CABINET MEMBER FOR ENVIRONMENT – 25 MARCH 2021 STEVENTON – HANNEY ROAD – PROPOSED TRAFFIC CALMING MEASURES

Report by Corporate Director, Environment and Place

Executive summary

Annexes Annex 1: Plan of proposed traffic calming measures

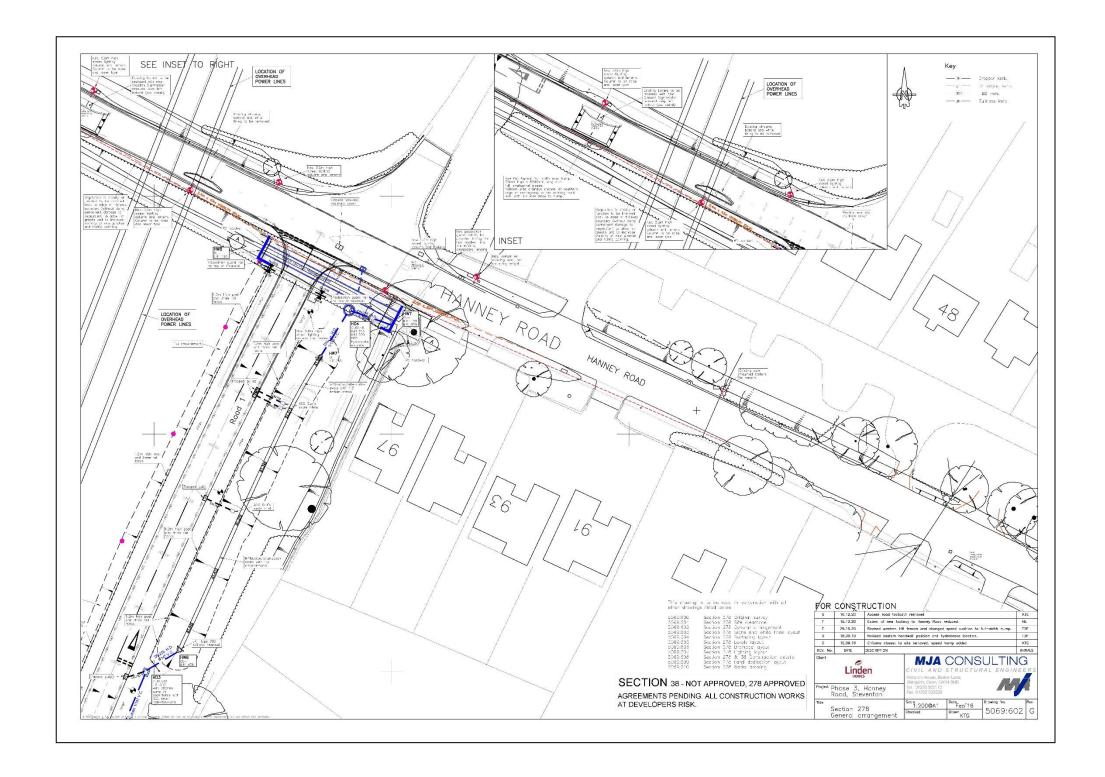
RESPONDENT	COMMENTS
(1) Traffic Management Officer, (Thames Valley Police)	No objection
(2) Vale of White Horse District Council	No objection
(3) Local Resident, (Steventon)	Object – Having lived on the Hanney Road for many years I can tell you putting a road hump in will not make any difference what so ever, as soon as the cars get over the hump they will be speeding down the road, there are no signs to say the speed limit is 30 mph on this stretch of the road, not that car drivers would take any notice, the only thing that will reduce speed is speed cameras and I don't understand why this has not been done already, I would also like to comment on the huge lorries on the Hanney Road coming and going to the depot, all through the night we are woken up by these lorries and my house shakes when they go past, they are enormous, it is only going to get worse with the amount of new housing being built in Grove and Wantage so I would like the council to consider speed cameras.

(4) Local Resident, (Steventon)	 Concerns – As residents living on the Hanney Road for many years we have witnessed the deterioration of the road and ever-increasing traffic movements. We have with other residents made known our concerns over this and have documentary evidence to back up this statement. Your recent letter directed us to the detailed plan for the proposed traffic calming measures. 1. The closeness to the bend on the western side restricts the vision in that direction to both oncoming traffic and emerging traffic from Harding Vale. 2. Unless the road pad is made of very substantial material it will not deter traffic from Hanney in making a bid for the "the gap". We know this from daily experience because we see and hear it. Your plans to put speed limit signage will have little effect in time (a) because they are mud splattered and (b) because they are generally ignored.

3. The calming measures in no way take account the underlying issues here. (i) unsuitability of a small rural road for the regular and heavy vehicle movement, primarily to and from Steventon Storage Depot; (ii) the road surface has not been properly maintained since the 1970s and occasional visits by Pothole Repair Team do not solve the problems; (iii) the road surface is indented and the banks are eroded, the drainage system is blocked and pedestrian movement, of which there is much, is threatened.

(5) Local Resident, (Steventon)	Concerns – The Hanney Rd in and out of the village is virtually a straight road of some distance and the 30mph speed restriction is abused to dangerous levels for a residential B road. A large volume of the cars, vans, and huge amount of HGV & other commercial vehicles that use this road do not observe this speed limit. The existing chicane is not fit for purpose and the newly installed speed calming humps at the Barnett Rd junction are totally ineffectual, with the only drivers who slow down are those who are turning in to Barnett Rd.
	My hope is, and that of many residents of the Hanney Rd, that the new configuration at the Harding Rd junction will slow the traffic down from both directions and make drivers obey the speed restriction. My worry is that after seeing the complete waste of time, effort and money the traffic calming at the Barnet Rd junction is, that the same will happen at the Harding Rd junction and make not a jot of difference to the current intolerable situation.

(6) Resident, (Wantage)	Concerns – The existing traffic calming measures have not been maintained for years and are in a dreadful state. The keep left signs have been broken and not replaced on numerous occasions. While they have been there, they were allowed to get so dirty that the sign was not readable.
	So while it is a good idea to remove half of the built out kerb, I am concerned that the Council will continue to maintain the feature, leading to it becoming very dangerous for motorists. The height and steepness of the calming ramp seems excessive and could cause damage to vehicles.

(7) Local Resident, (Steventon)	Support – I strongly agree with traffic calming on the road. I live at 97 Hanney Road which is the last house before you leave the village. I have witnessed a number of accidents due to speeding cars and lorries and believe it to be a matter of time before someone is hurt. I feel there should be more calming measures. Such as visual flashing lights telling people to slow down. Also, the road needs resurfacing due to the heavy traffic. When lorries speed past the houses shake.

- 11. Noting the above concerns, the proposed addition of a road hump can be expected, on the basis of experience with other similar schemes, to be appreciably more effective than the current layout in reducing speeds. It is accepted that the road does carry appreciable traffic including commercial vehicles reflecting in part the commercial storage site but these concerns are not considered to be within the scope of the proposals under consideration as, similarly, are the requests for additional speed management measures further east on the Hanney Road.

- 12. The concerns over the maintenance of the road are noted and will be referred to the area team for inspection and assessment.
- 13. One expression of support was received from a local resident, although this also mentioned the need for additional traffic calming measures further east and also concerns over the maintenance of the road.
